2016SYE008 – 316-320 Taren Point Road, Caringbah

DA15/1586

## ASSESSMENT REPORT APPENDICES

**DRAFT CONDITIONS OF DEVELOPMENT CONSENT**  
**Development Application No. DA15/1586**

SCALE 1:250@A1 1:500@A3	DATE 11/12/2015	DRAWN HS	CHECKED MS
JOB 15069	DRAWING DA 4.08	REVISION B

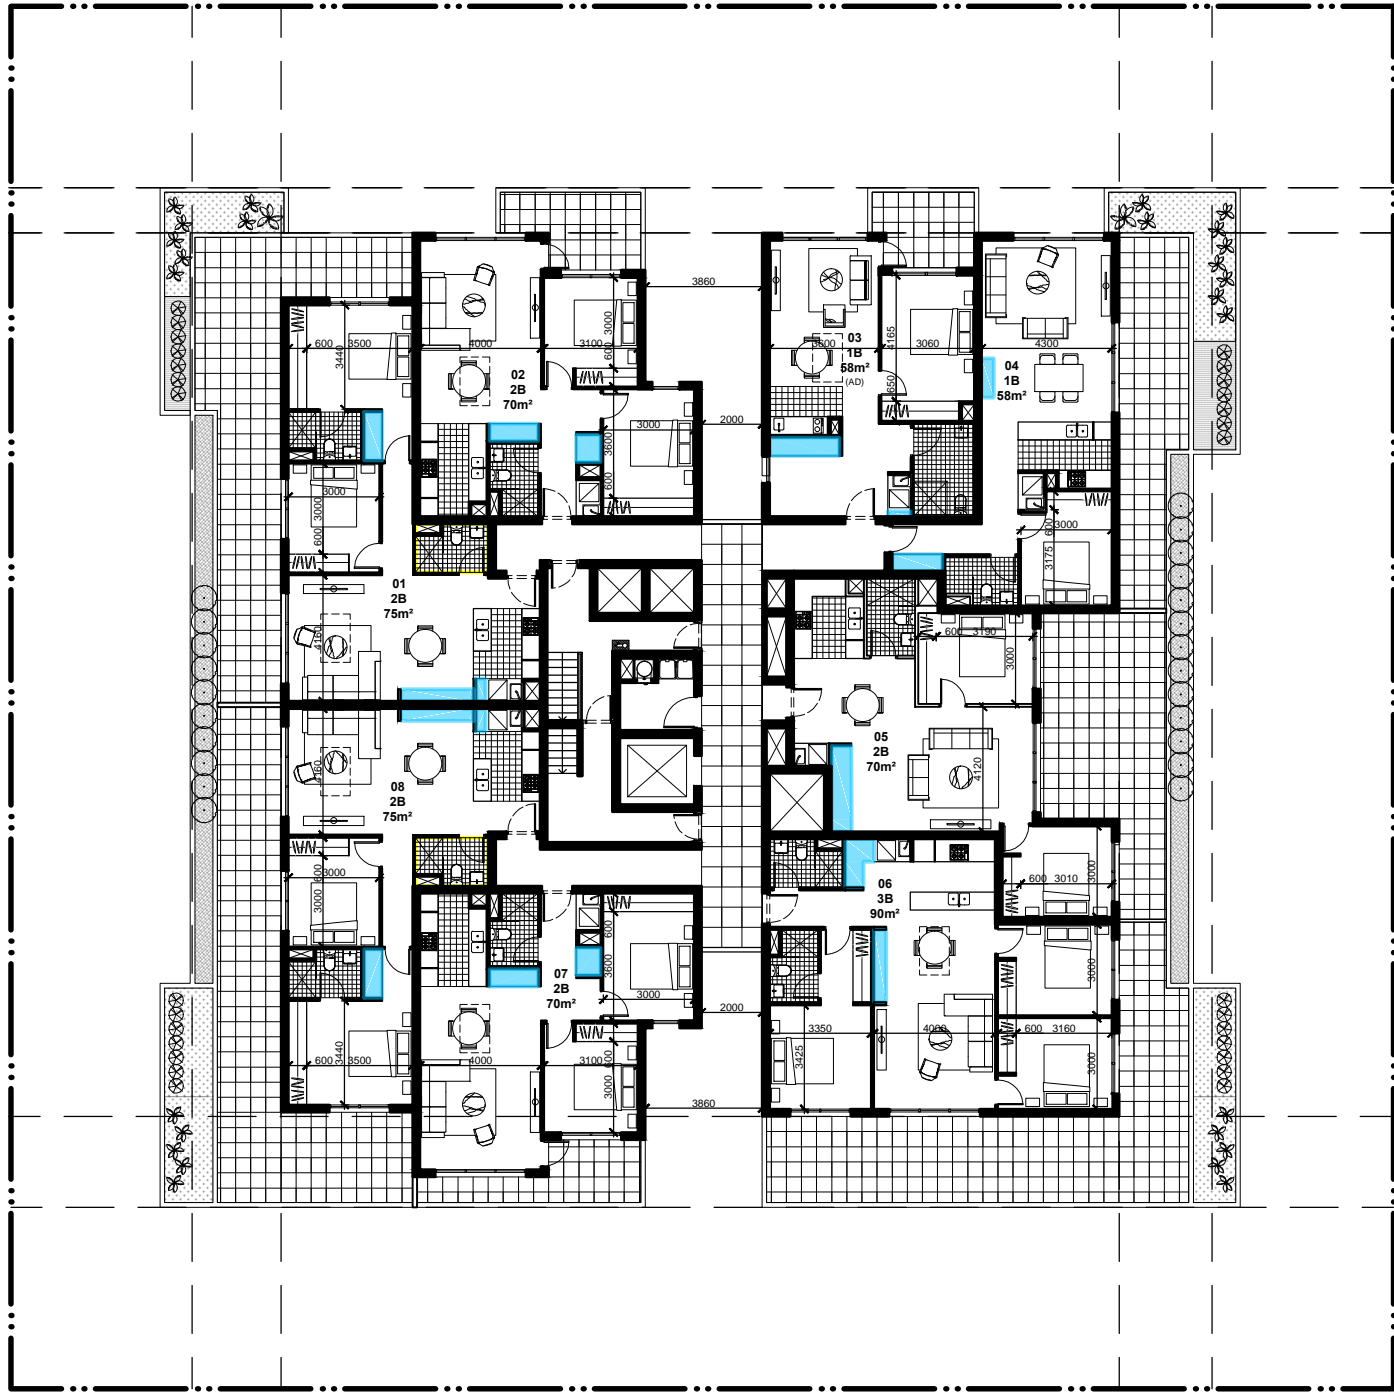
- viii) All storage areas shown in blue on the Storage schedule (DA4.08/B dated 12 May 2016) must be fitted with built in cupboards, shelves or the like.

VERIFIED	CD
DATE DRAWN	24/11/2015
PROJECT NUMBER	15731
DRAWING NUMBER	ISSUE
LS-201	D

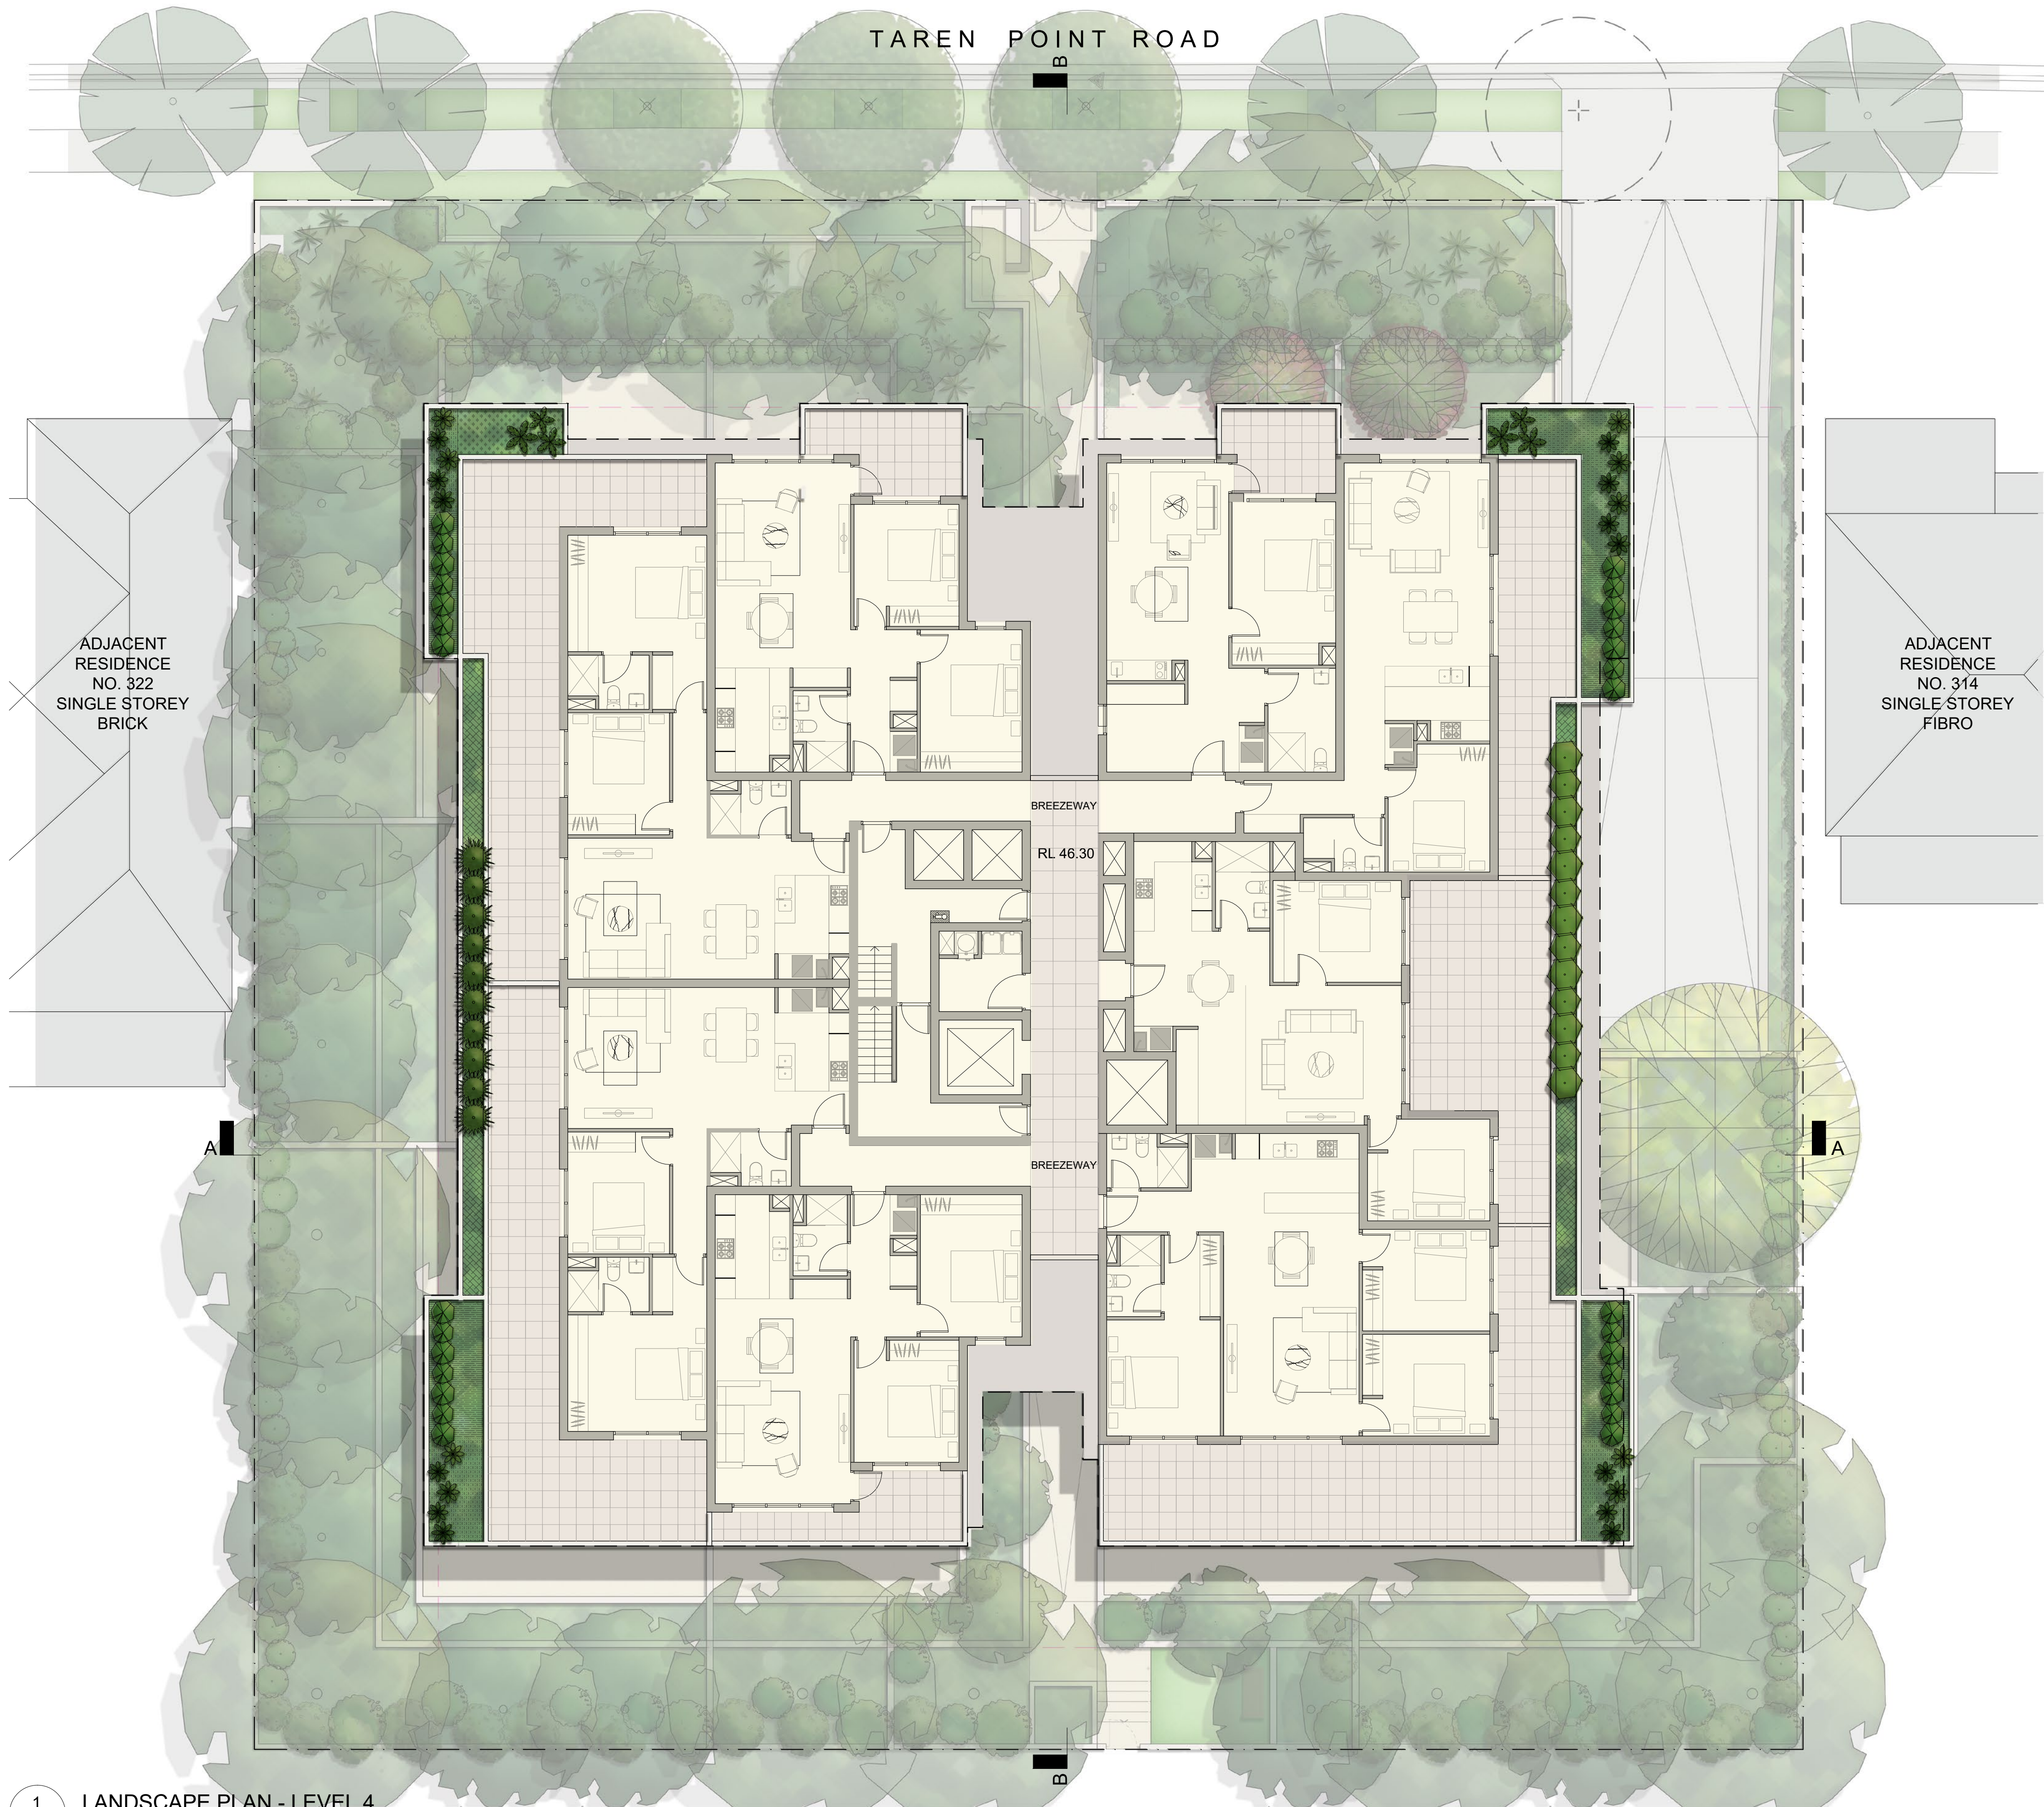
Delete *Rytidosperma fulvum* (Wallaby Grass) and *Themeda australis* (Kangaroo Grass) to Groundcover Mix C for Western Boundary listed in the planting schedule and replace with *Lomandra multiflora* (Matt Rush), *Dianella caerulea* (Flax lily) and *Hardenbergia violacea* (Native Sarsparilla).

Replace *Lagerstroemia indica* (Crepe Myrtle) with two *Backhousia myrtifolia* (Grey Myrtle)

Replace *Banksia integrifolia* (Coastal Banksia) with two *Backhousia myrtifolia* (Grey Myrtle)

*Syzgium* or *Acmena* spp. to planting bed adjacent to basement driveway

Splay entry to development from 113 Willarong Road and provide communal seating to cleared appears either side of stair access

Replace two CA with two *Banksia serrata* (Old Man Banksia)

Delete EPU and replace with two *Banksia serrata* (Old Man Banksia)

Delete BI and replace with one *Banksia serrata* (Old Man Banksia)

Replace two CA with one *Banksia serrata* (Old Man Banksia)

DRAWING NUMBER	ISSUE
LS-202	A

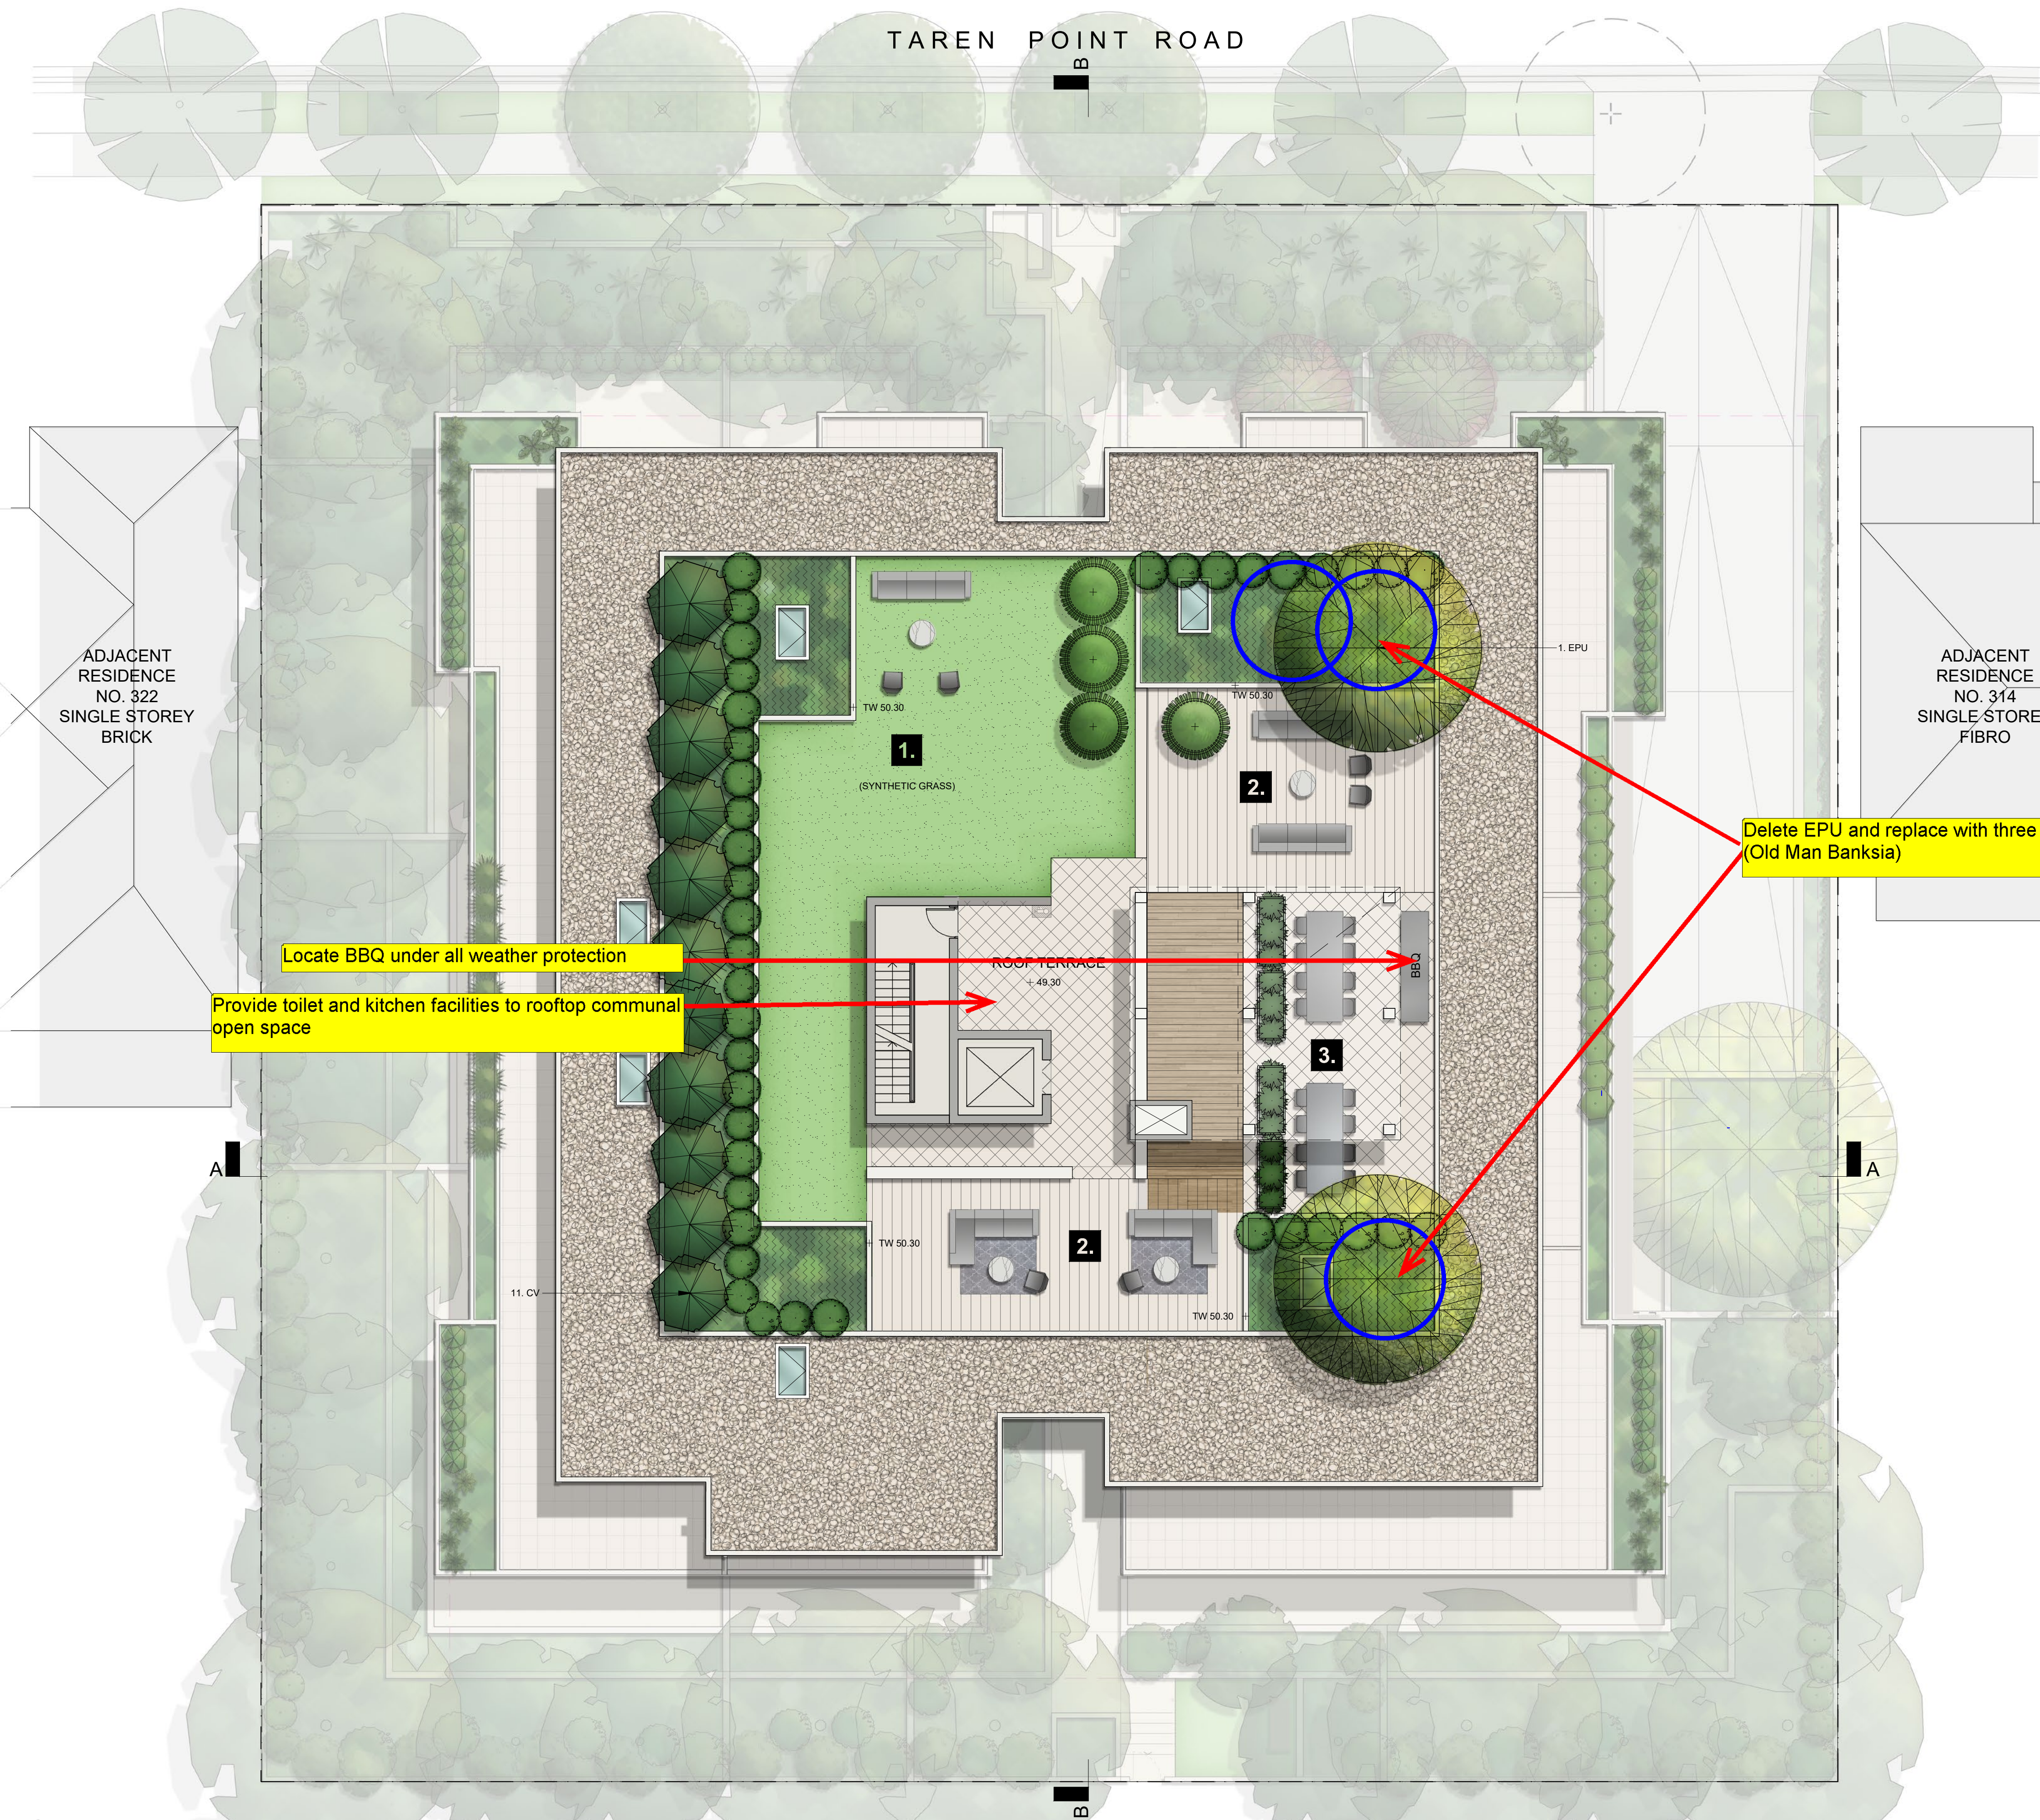
Provide toilet and kitchen facilities to rooftop communal open space

Delete EPU and replace with three Banksia serrata  
(Old Man Banksia)
